Preservation Department – Item 1, LPC-23-08657

**346 Broadway (aka 108 Leonard Street, 46 Lafayette Street) – Former  
New York Life Insurance Building – Individual and Interior Landmark  
Borough of Manhattan**

# DESIGN REVISIONS

## IN RESPONSE TO COMMISSIONER COMMENTS

L1- SURFACE MOUNTED TRACKLIGHT

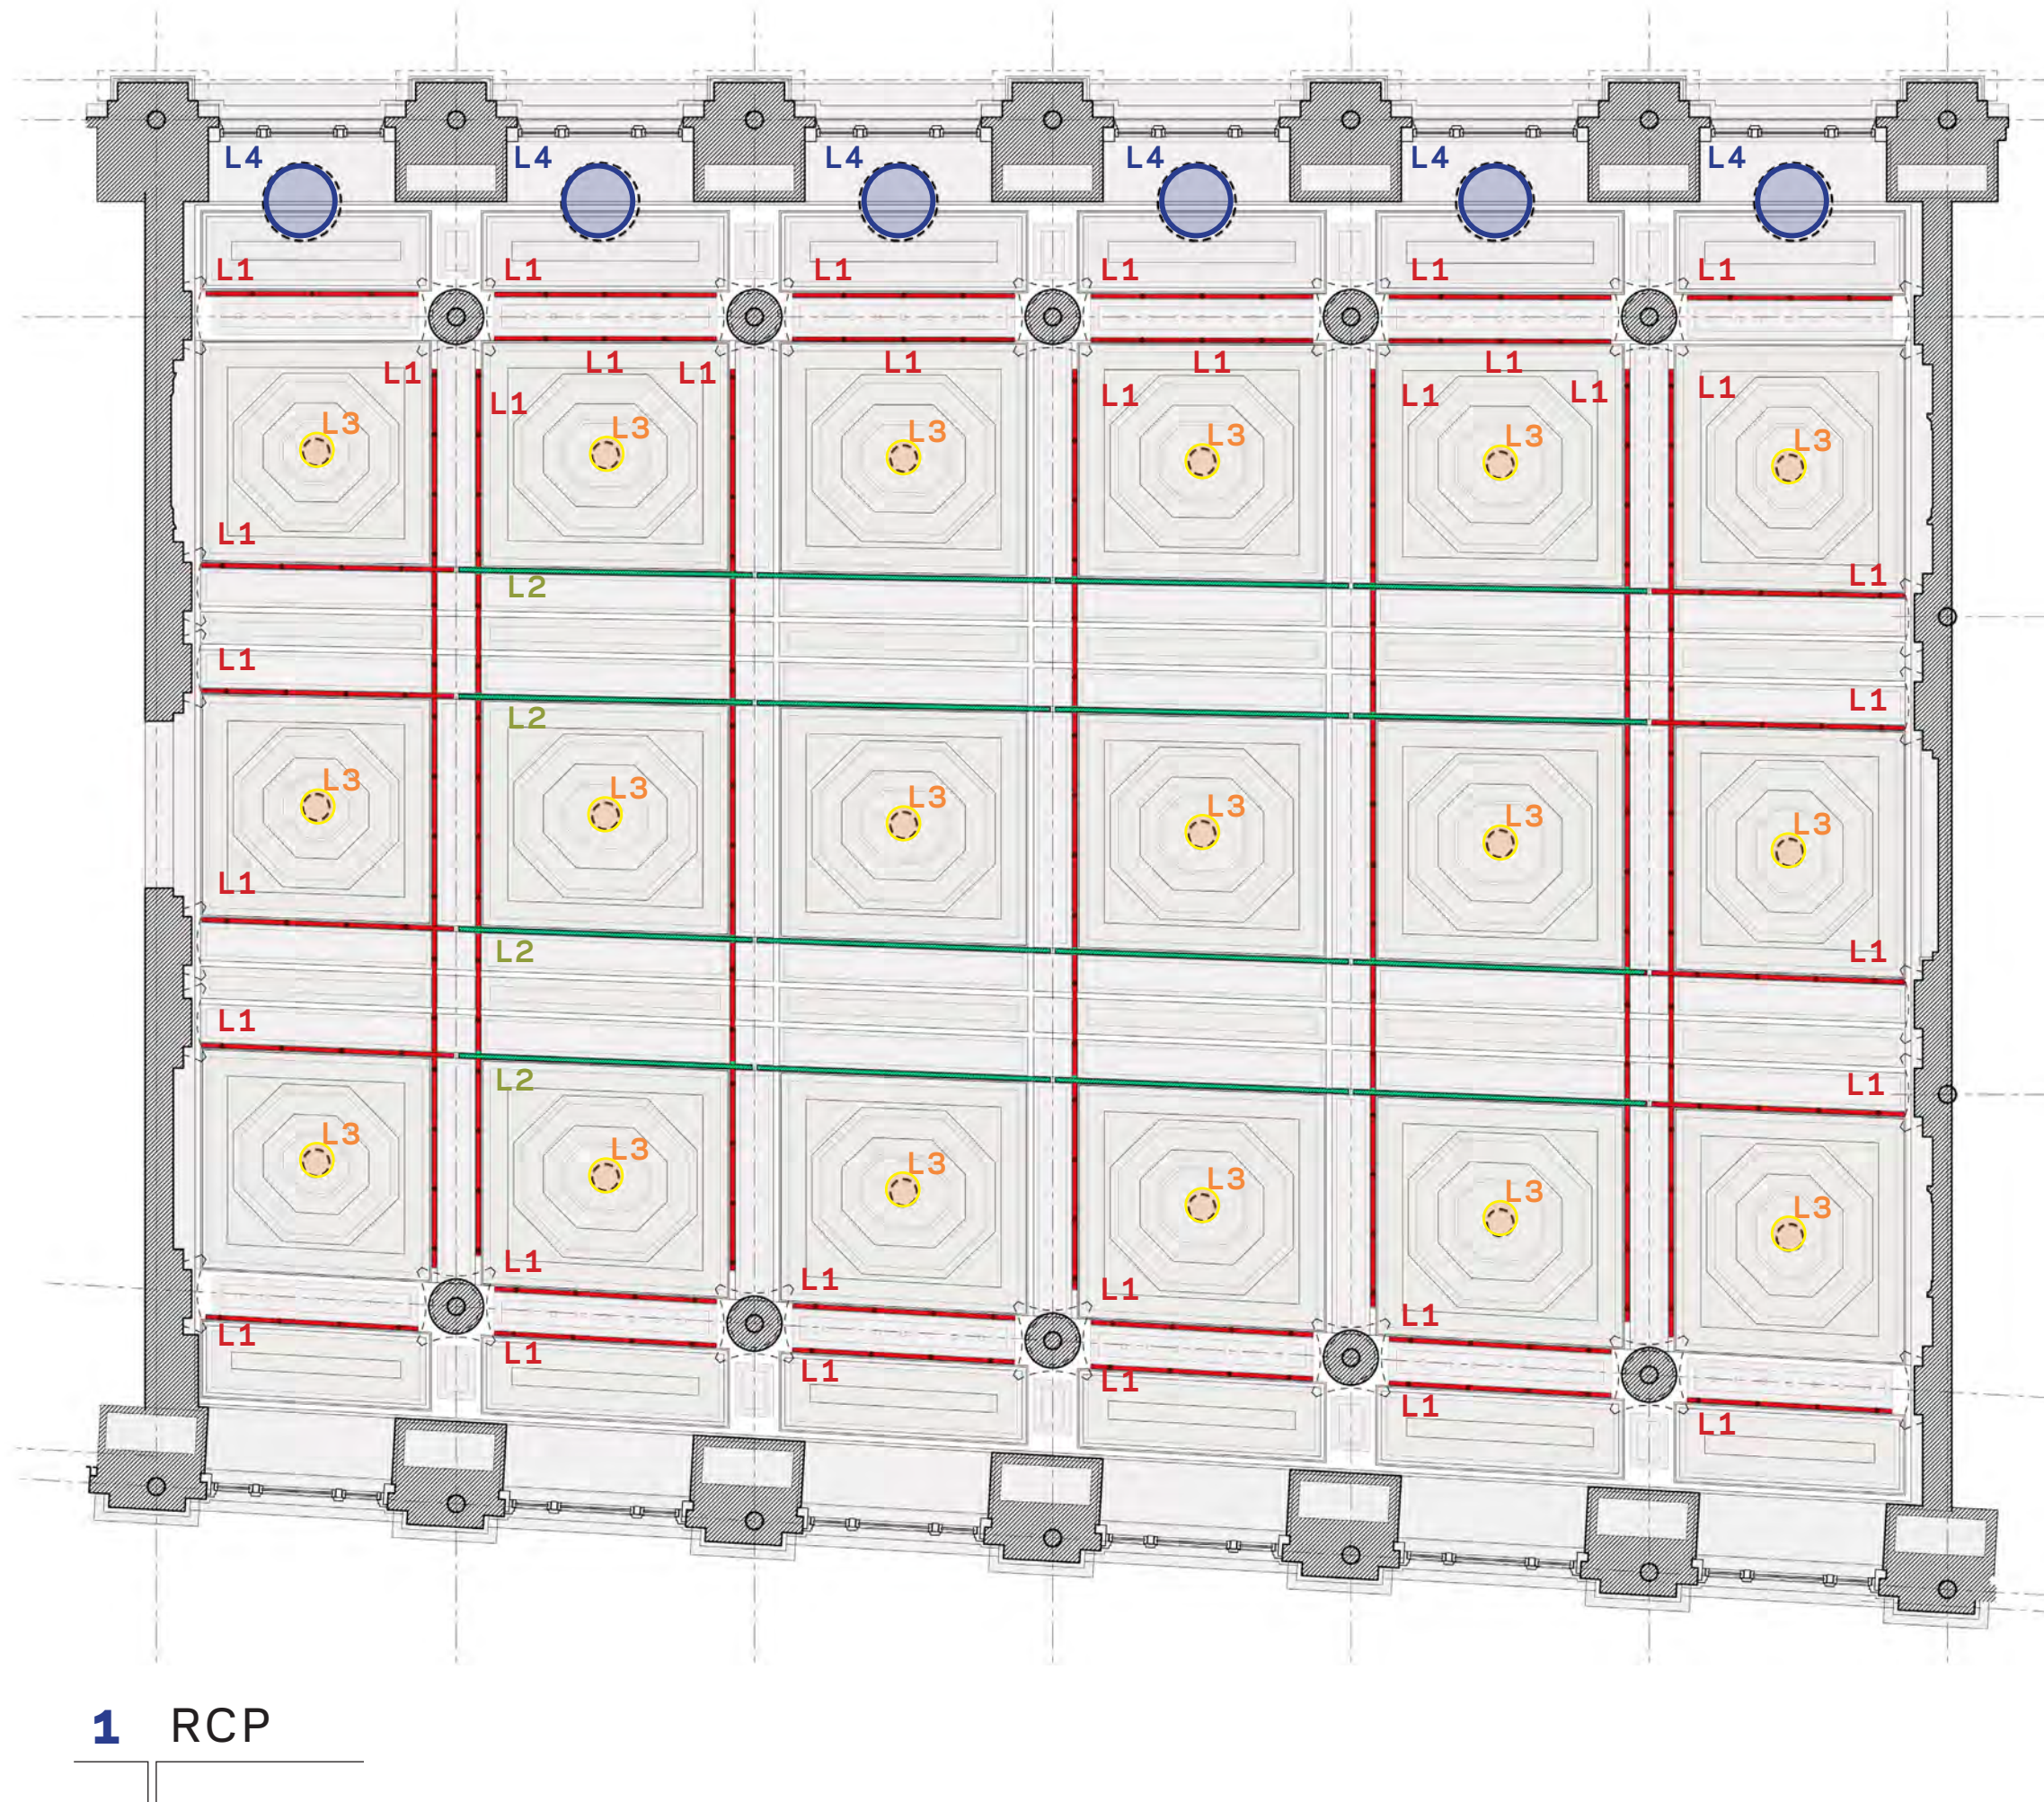
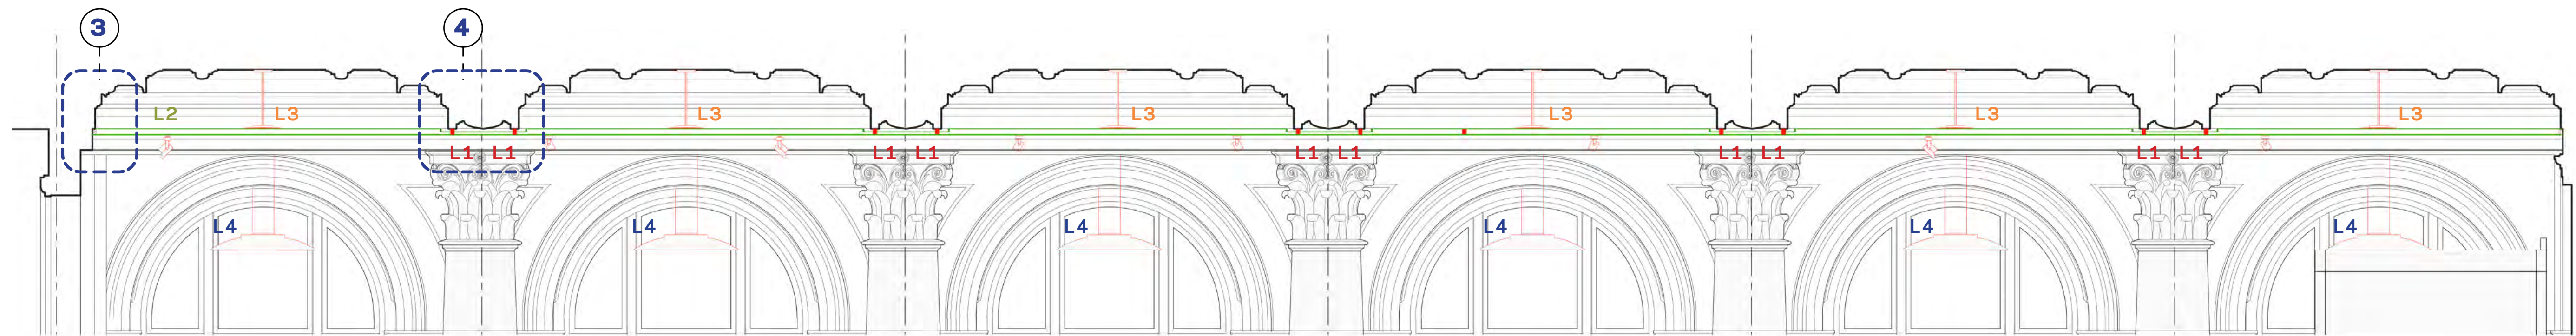
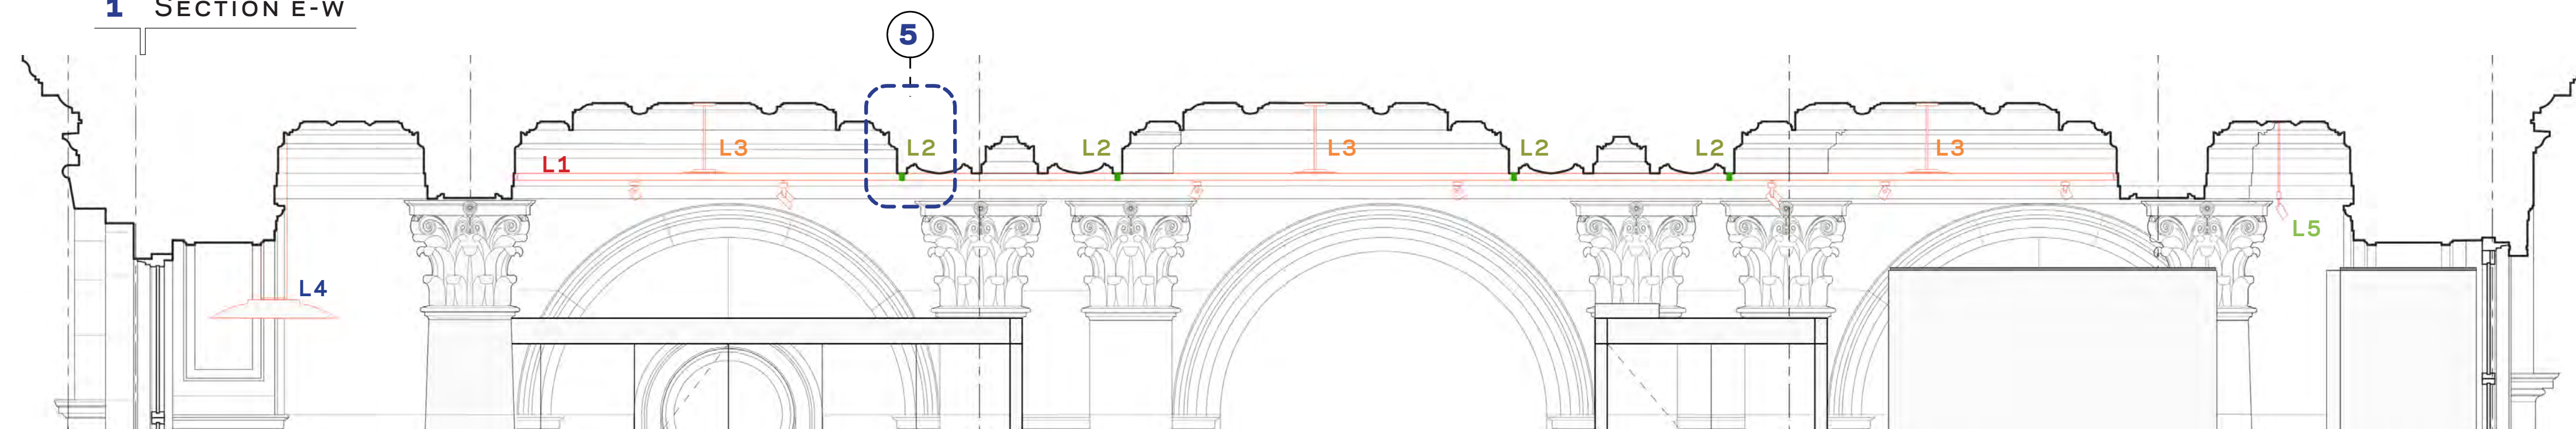
The lighting design has been revised to create a continuous system along the existing grid of the historic ceiling, which is articulated in flat plaster. This system is a minimal approach that reinforces the architectural expression of the ceiling and is finished to match the ceiling. The pendant lights, which uplight each coffer, have been raised so as to not break the plane of the grid and will have a dark finish consistent with the rosettes that originally occupied the coffers.

The lighting design will maintain and reinforce the existing pattern of intersecting straight lines.
